HYDROLOGY

TITLE: Street Grading, Soil Cement, Storm Sewer, & Water Plan & Profile
THE COLONNADE

TITLE: Grading and Developement Plan
THE COLONNADE

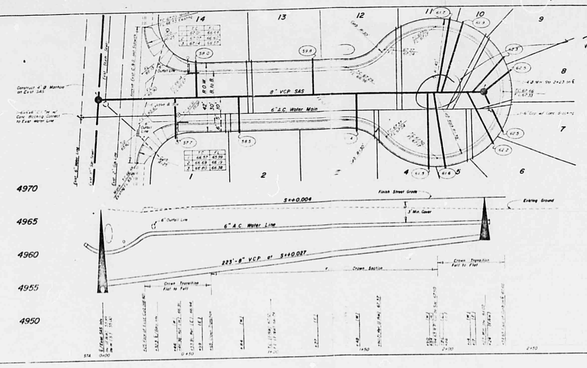
TOO MANY CONNECTIONS PER JOINT OF VCP → PREFER 1 PER JOINT
